Project	<b>IEEE 802.16 Broadband Wireless Access Working Group</b> < <a href="http://ieee802.org/16">http://ieee802.org/16</a> >	
Title	<b>Modifications to the TG1 MAC for use in TG4 Systems</b>	
Date Submitted	<b>2001-01-13</b>	
Source(s)	Subir Varma Aperto Networks 1637 South Main Street Milpitas, CA 95035	Voice: (408) 719 9977 Fax : (408) 719 9970 mailto:svarma@apertonet.com
Re:	IEEE 802.16.1/D1-2000, December 2000	
Abstract	The objective of this contribution is to comment on certain aspects of the TG1 MAC protocol, from the point of view of its suitability for TG4.	
Purpose		
Notice	This document has been prepared to assist IEEE802.16. It is offered as a basis for discussion and is not binding on the contributing individual(s) or organization(s). The material in this document is subject to change in form and content after further study. The contributor(s) reserve(s) the right to add, amend or withdraw material contained herein.

# Modifications to the TG1 MAC for Use in TG4 Systems

FIGURE 3.

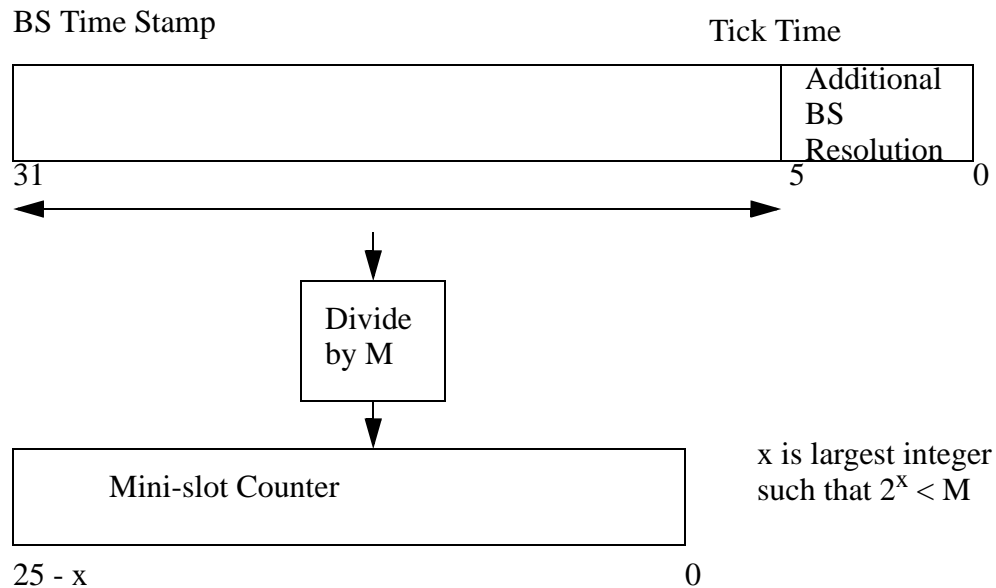
In order to resolve these issues, we propose the following alternative time base definition:

The base time unit is called a tick and is of duration 1 us, independent of the symbol rate, and is counted using a 26 bit counter. The additional BS resolution is of duration  $(1 \text{ tick}/64) = 15.625 \text{ ns}$ . The BS uses a 32 bit counter, of which the most significant 26 bits are used to count the ticks. The Mini-Slot count is derived from the tick count by means of a divide by M operation. Note that the divisor M is not necessarily a power of 2.

Figure 3 (of this contribution) illustrates the mapping of the System Time Stamp maintained in the BS to the BS mini-slot counter. The BS and SS base their transmit or receive allocations on a 32-bit counter that normally counts to  $2^{32}-1$  and then wraps back to zero. The 26 most significant bits of this counter are subject to a Divide-by-M operation, to derive the mini-slot counter.

**FIGURE 4. MAP relevance for burst PHY systems**

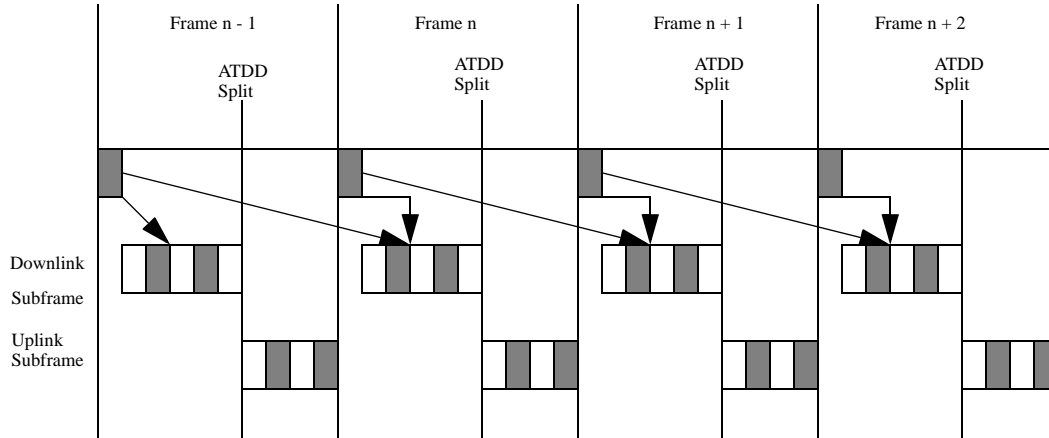
*Replace Figures 53 and 56 in the TG1 specification by Figure 4 of this contribution. Replace the text in Section 6.2.2.4.1 by the following:*

As shown in Figure 4, the portion of the time axis described by a MAP is a contiguous area whose duration is equal to the size of a frame. In the example shown in Figure 4, it consists of a portion of the downstream time of the frame in which MAP is contained, the upstream time in this frame, followed by a portion of the downstream time in the next frame. The fraction of the downstream time in the current frame (or alternatively, the Allocation Start Time), is a quantity that is under the control of the scheduler, and when set to zero, corresponds to the Minimum Time Relevance scenario in Figure 59 of the TG1 specification. Note that with this design, it is no longer necessary to use a pre-defined set of frame sizes, but it can be changed under the control of the scheduler.

**FIGURE 12. MAP Message Format**

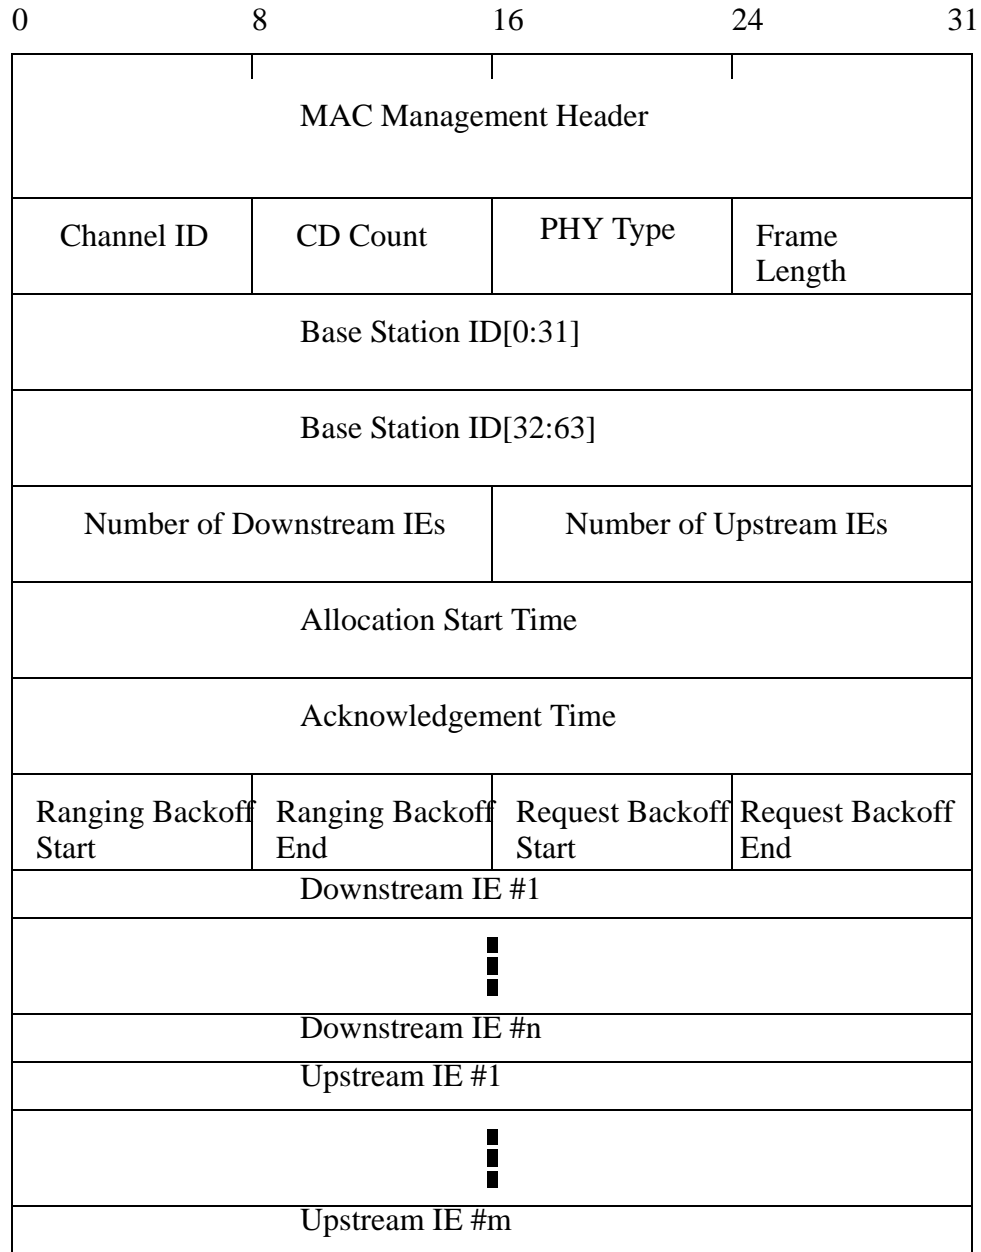
Replace the contents of Section 6.2.1.2.3 by the following:

The MAP message allocates access to the upstream channel for FDD systems, and to both downstream and upstream slots for TDD and HD-FDD systems.

FIGURE 18. SYNC Message Format

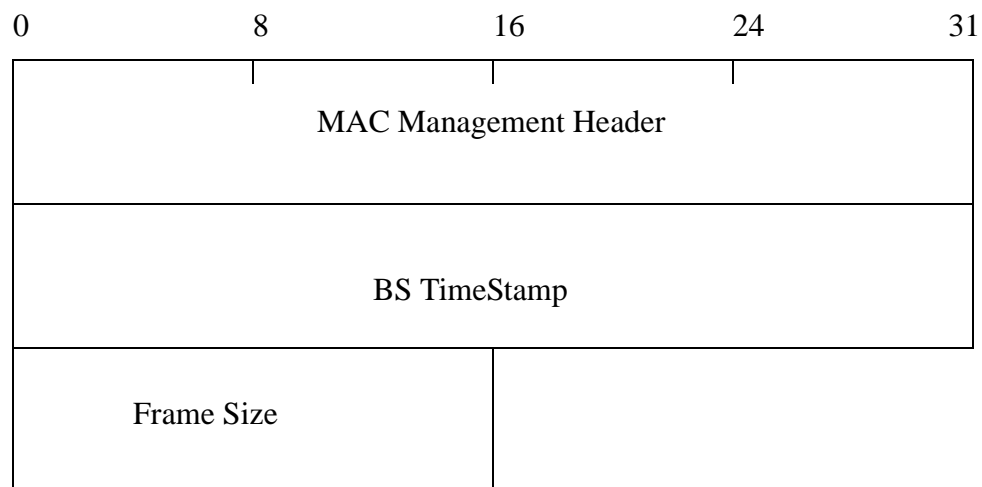
Replace the contents of Section 6.2.1.2.4 by the following:

The SYNC packet carries the 32-bit timestamp from the BS to each of the SS. The SYNC message format shall be as shown in Figure 15

**FIGURE 19. TDD Frame Structure with M mini-slots per frame**

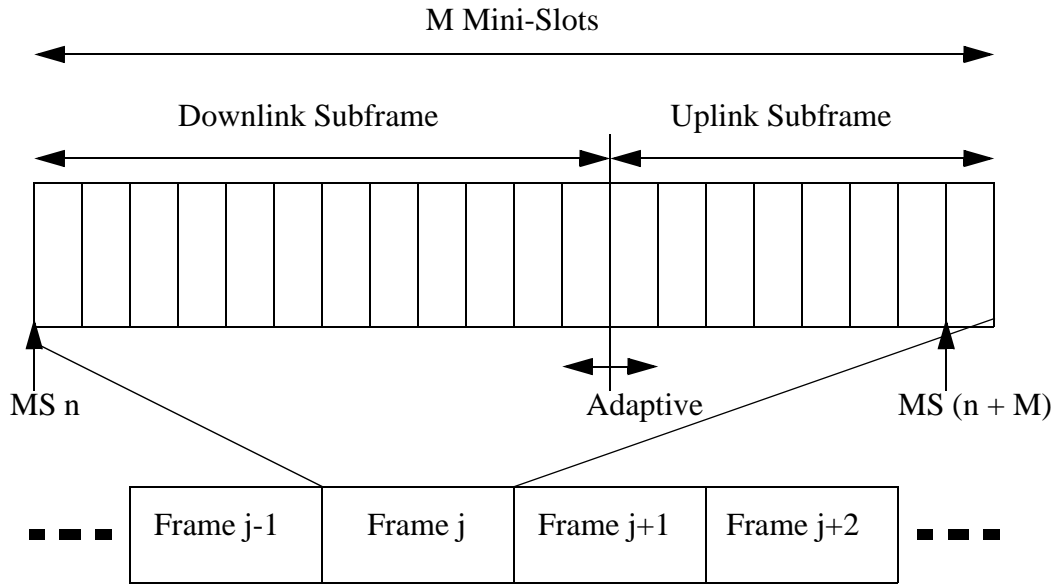
*Replace Figure 121 by Figure 19 above. Replace the contents of Section 6.2.2.3.1 with the following:*

The available bandwidth in both directions is defined with the granularity of one tick, which is of duration equal to one microsecond. The number of ticks with each frame is independent of the modulation rate. The Mini-Slot count is derived from the tick count by means of a divide by M operation. Note that the divisor M is not necessarily a power of 2. For arbitrary symbol rates, the main constraint in the definition of a mini-slot, is that the number of symbols per mini-slot be an integer. For example given a symbol rate of R Symbols/tick, and M ticks/mini-slot, the number of symbols per mini-slot N, is given by  $N = MR$ . In this situation, M should be chosen such that N is an integer. The frame size should be selected so that the number of mini-slots per frame is an integer.
